Replacement of High Altitude and Sea Level Pressure Switches

Models: ADD AUD, CDB, CUB, FCA, FUA, TDD, TDE, TUD, and TUE

Literature Order Number	PART-SVN55C-EN
File Number	SV-SP-PART-SVN55C-EN-0505
Supersedes	SV-SP-PART-SVN55B-EN-0904
Stocking Location	Electronic only

Figure 1. SWT02357 and CNT03814

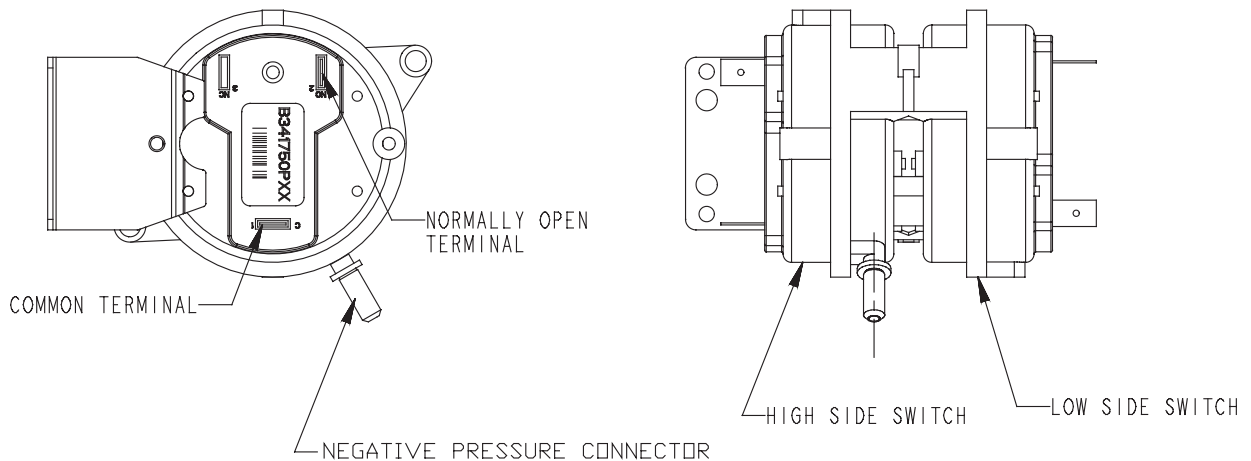
The superceded switches are low pressure, single pole, normally open pressure control switches and are no longer available. Switch, SWT02357 and Control, CNT03814, are functional replacements, although there are some minor differences between the two. The replacement control is a high and low pressure unit. When used as replacements for single stage furnaces, terminate the wires on the normally open and common terminals on the HIGH-pressure side of the switch, see Figure 1.

When used to replace one or both of the switches on a two stage furnace, both original switches need to be removed and discarded. Connect the wiring for low fire to the LOW pressure side and connect the wiring for high fire to the HIGH pressure side. Discard the "T" for the pressure hose connections and connect the pressure switch hose to the negative pressure connector, see Figure 1.
